Structural RAIs

Presentation to NRC
June 18, 2009

RAI 2-12 (cont.)

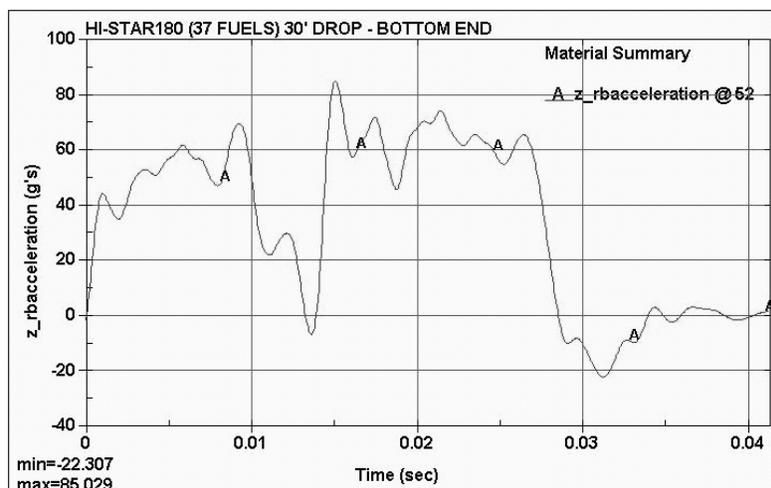
RAI: Justify the use of a limiting G load of 60 Gs when evaluating fuel performance during 9 meter bottom down fuel drop

Response: For the fuel rod integrity analysis, the impact limiter crush force is set based on the initial impact between the HI-STAR 180 package and the ground (i.e., before the gap between the fuel assemblies and Fuel Impact Attenuators (FIA) closes) as determined by LS-DYNA.

Response (cont.): The peak cask deceleration of 85 G predicted by LS-DYNA occurs after the fuel assemblies have impacted the FIA assemblies and have started to rebound. By that time, the most severe loading on the fuel pins has already occurred. Since the single fuel pin model explicitly includes the FIA spring and the 20 mm maximum clearance gap between the fuel assembly and the FIA, it is appropriate to set the impact limiter crush force based on the initial impact with the ground.

Response (cont.):
